1st Review
PRCCP20240569
June 2024

ASH DEVELOPMENT, LLC
EAST TOWN CROSSING
PUYALLUP, WA

PAVEMENT MARKING &
SIGNING PLANS - PHASE 1

TRAFFIC SIGNAL PLANS - PHASE 1

TS-01
SHEET:
OF

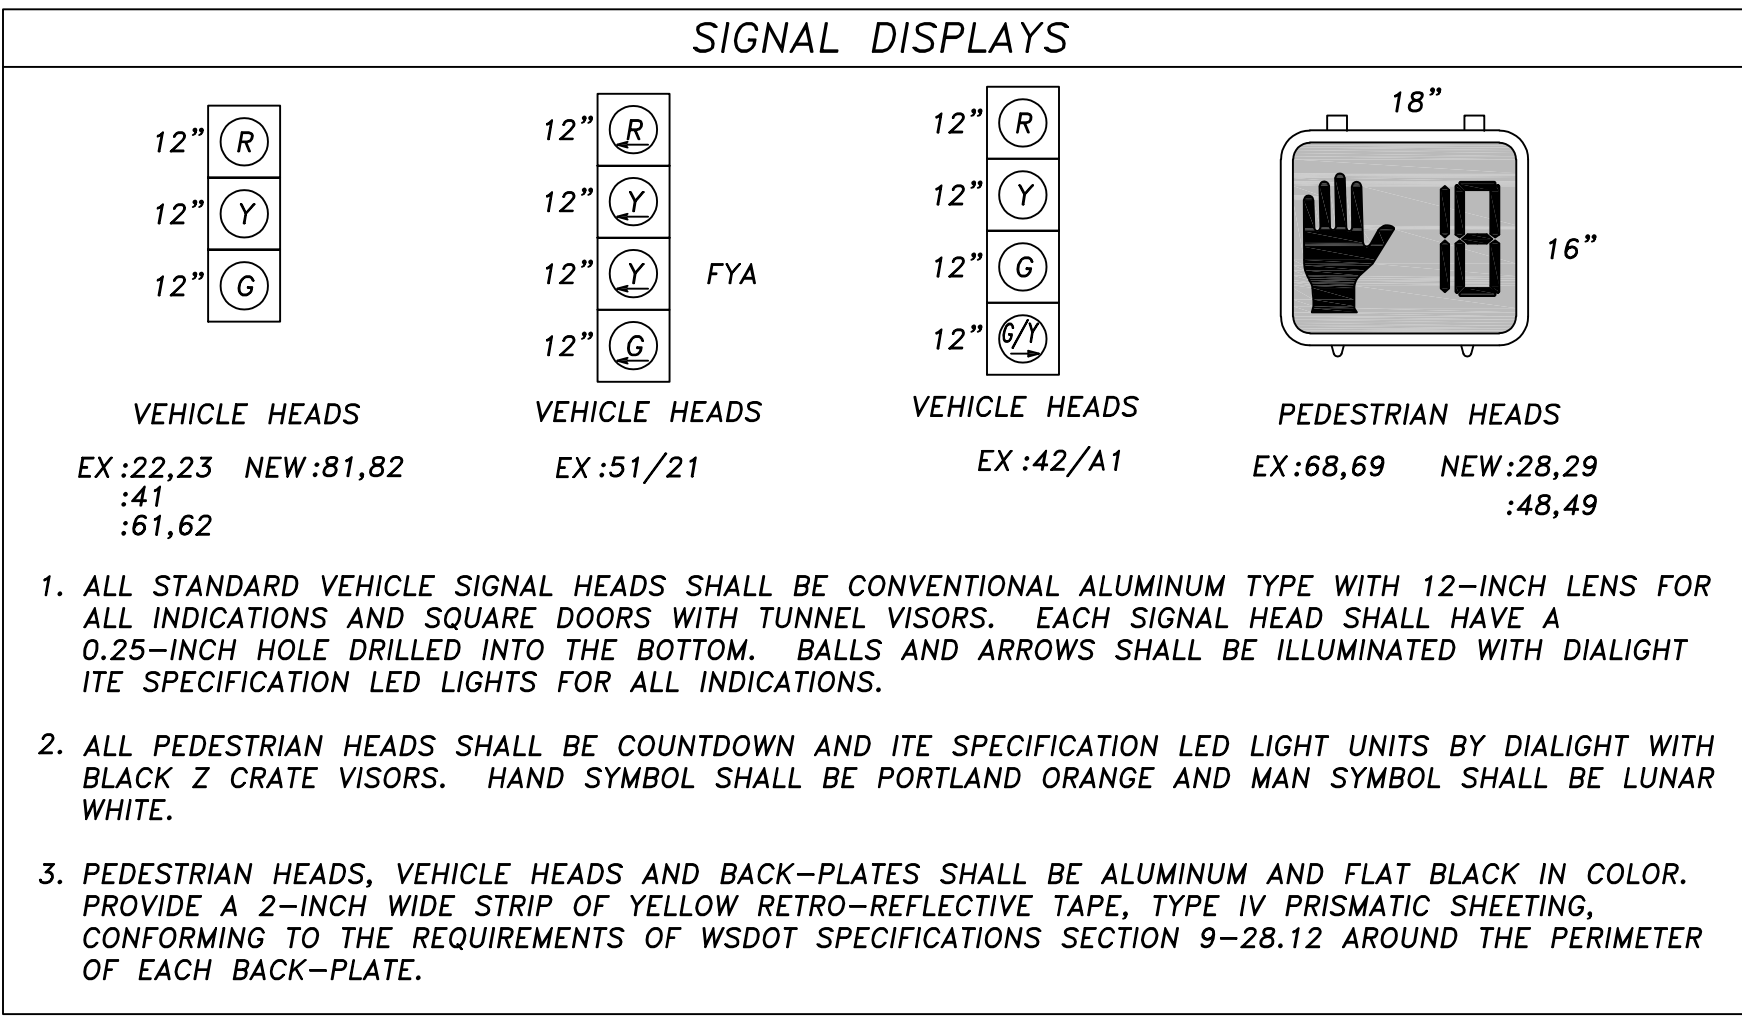
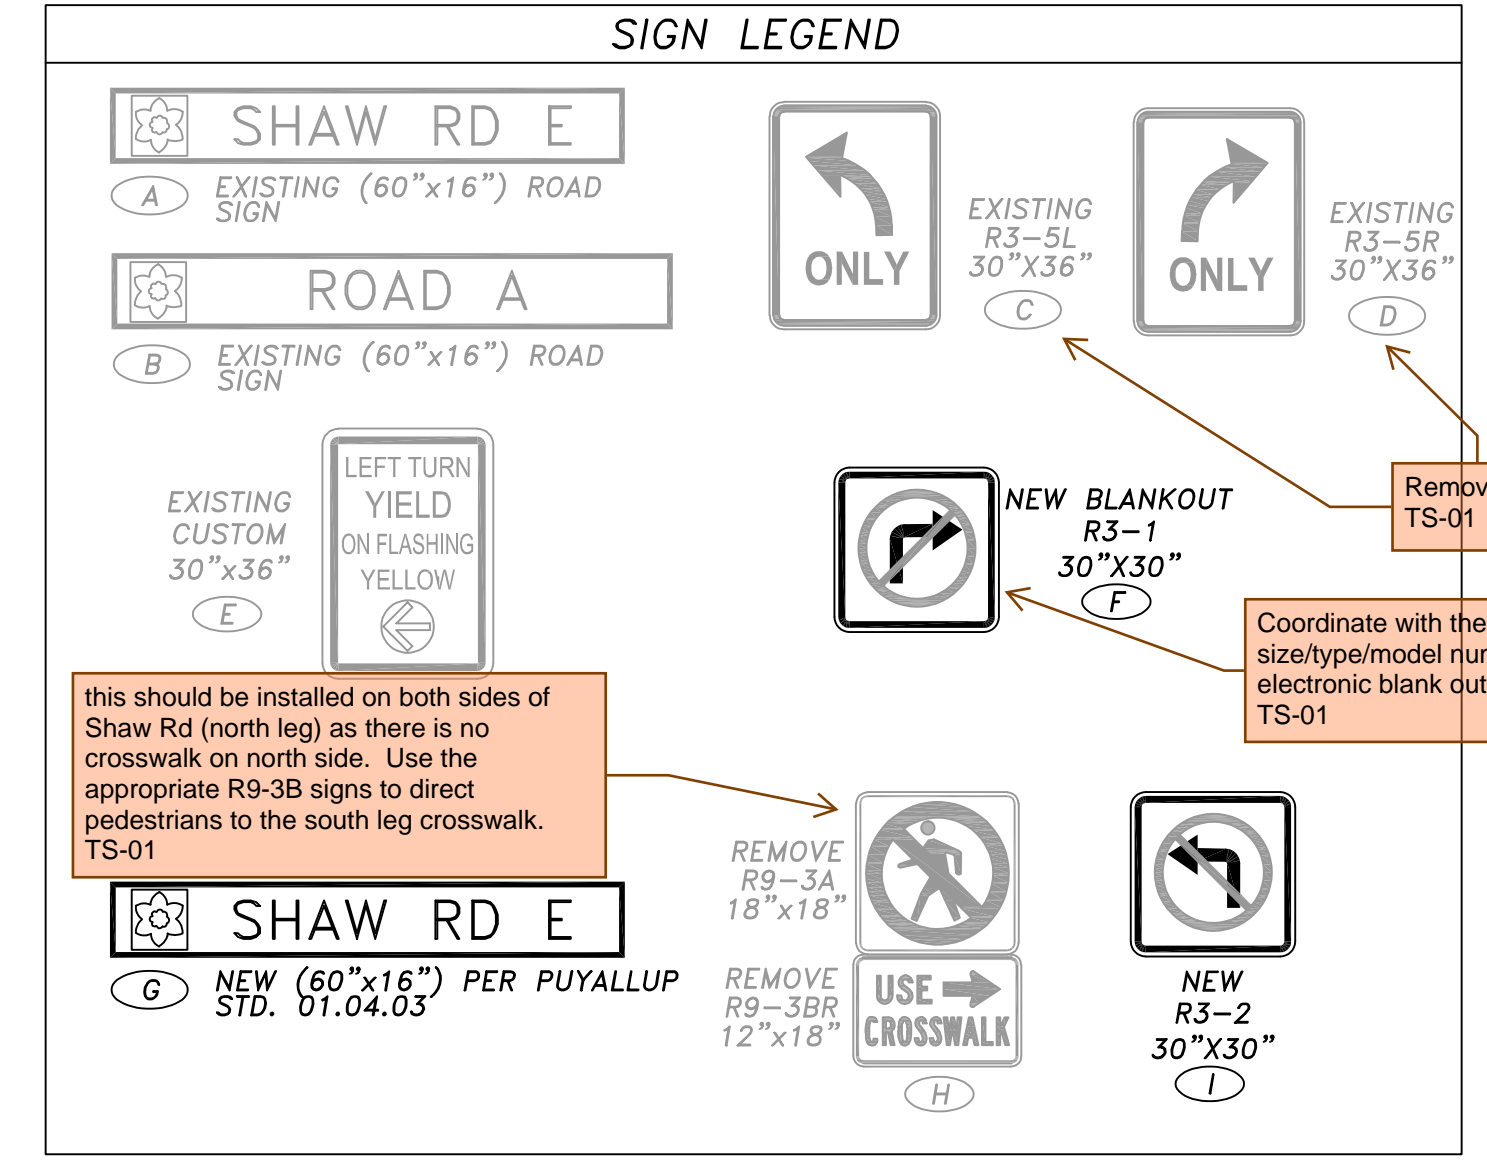
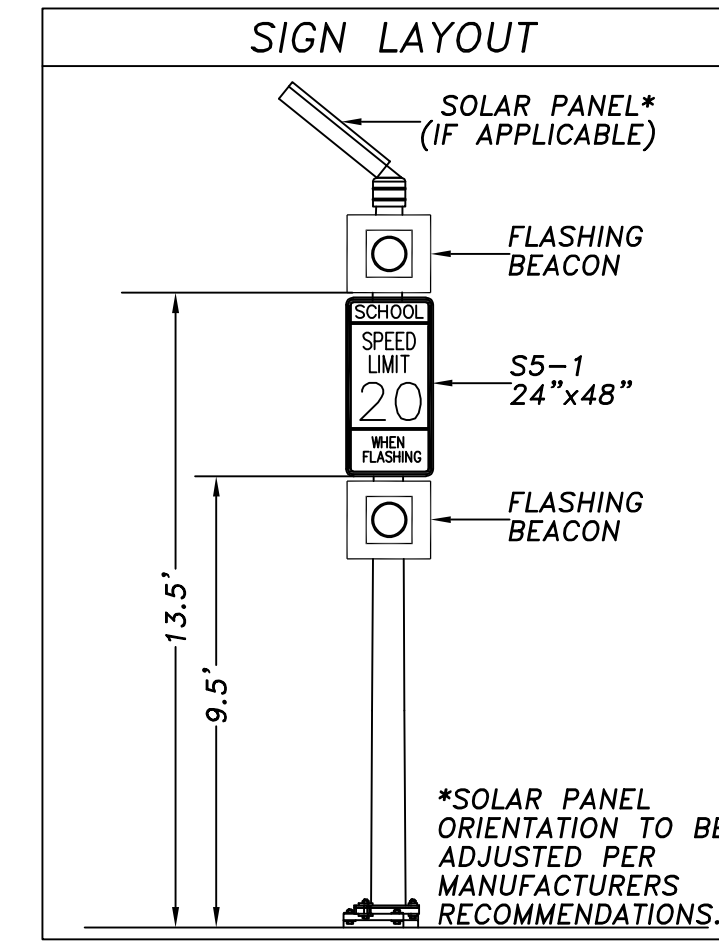
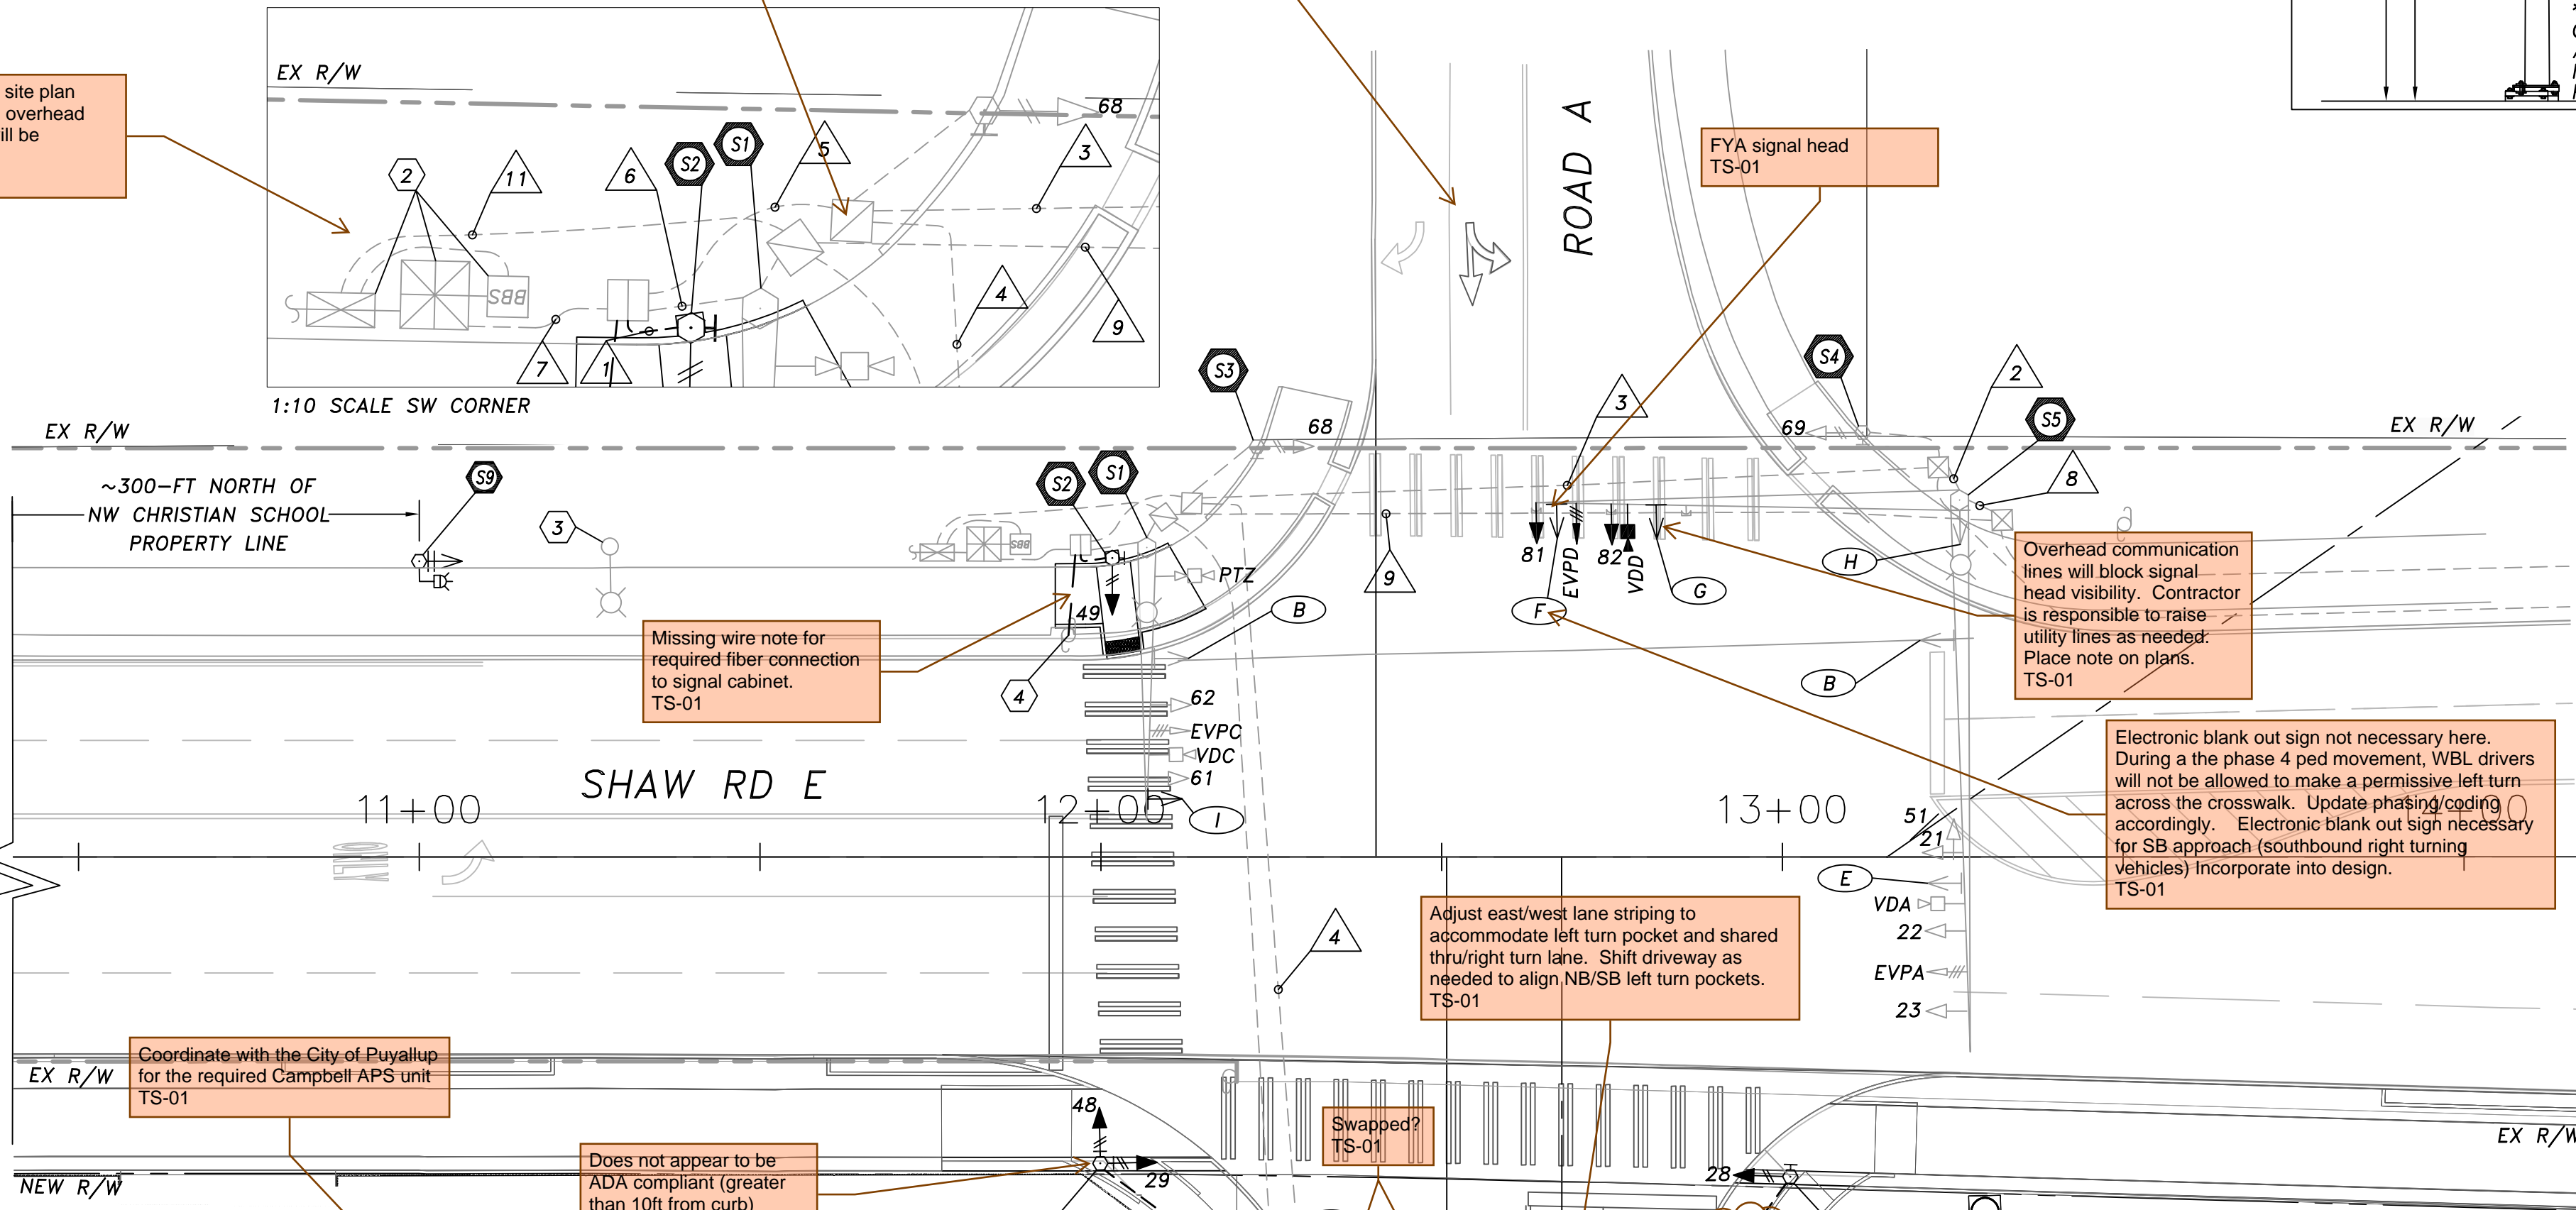
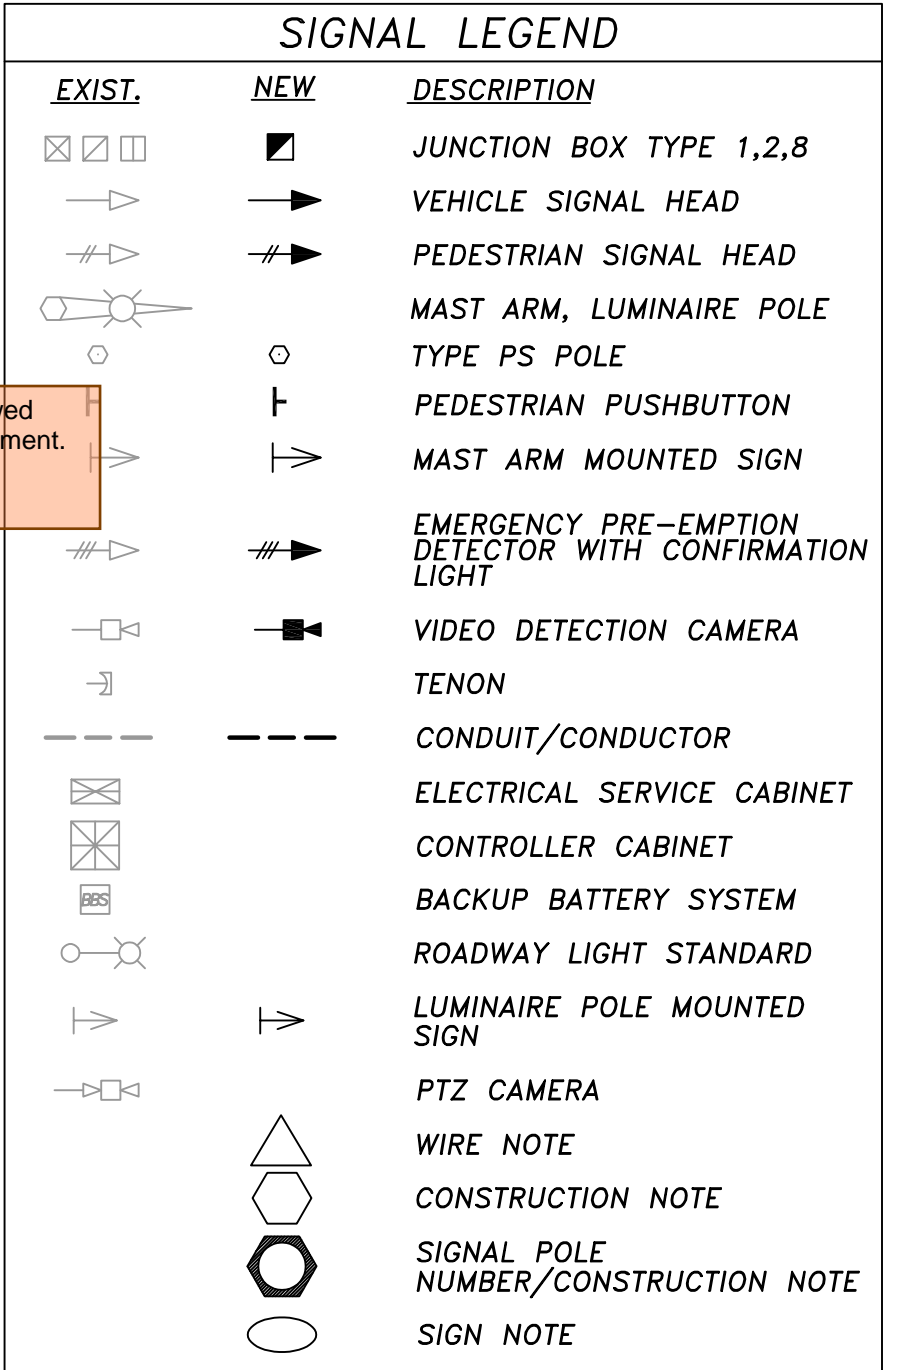
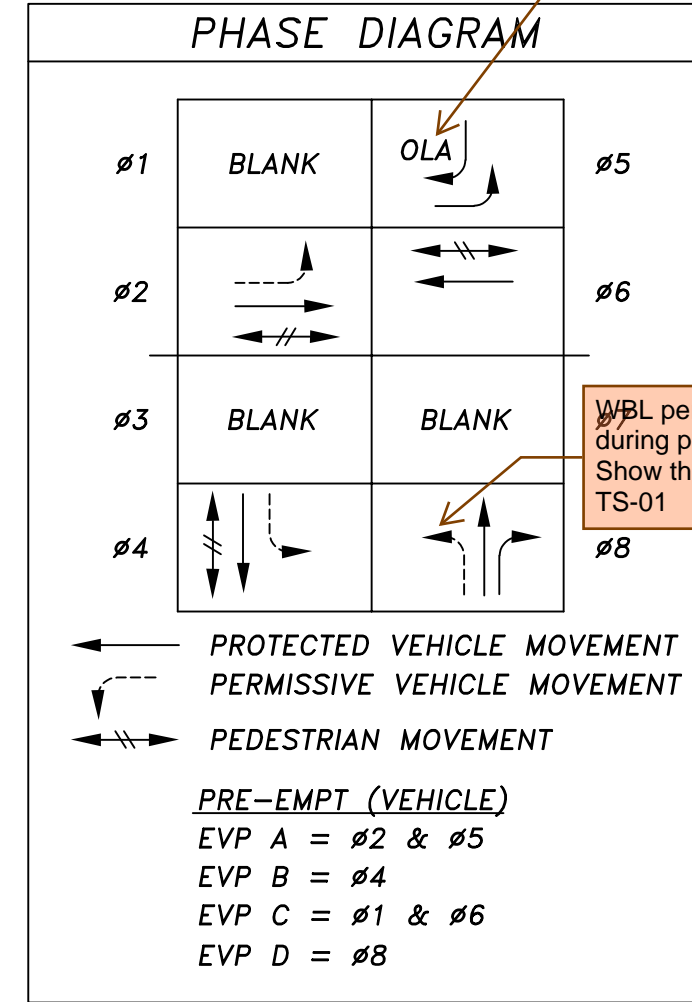
As condition with the preliminary site plan approval, the required signal/intersection modifications must be fully configured and operational no less than 2 weeks prior to receiving occupancy for any building on-site. Adaptive signal contractor (Rhythm Engineering) will be required to configure the adaptive system on-site. Adaptive contractor will provide setup/configuration/optimization (not completed by the City). Place this condition on the plans. TS-01

Adjust east/west lane striping to accommodate left turn pocket and shared thru/right turn lane. To accommodate this phasing, the EBR overlap must be removed TS-01

As condition with the preliminary site plan approval, Flashing yellow arrows with PT/PM phasing required for EB/WB left turns. Modify phasing as needed TS-01

Per the approved preliminary site plan conditions, provide details on overhead fiber connection and how it will be spliced/connected to cabinet. TS-01

Update phasing diagram to reflect PT/PM FYA operation for EB/WB. TS-01

To accommodate required channelization (left turn pocket and shared thru/right turn lane), EBR overlap must be removed TS-01

RSSZ flasher
-Coordinate with the City for required hardware & wireless interconnect
-Show conduit/j-box/power source/etc.
-Reference applicable WAC with placement/design justification.
-MUTCD compliant advanced signage/pavement markings missing from design TS-01
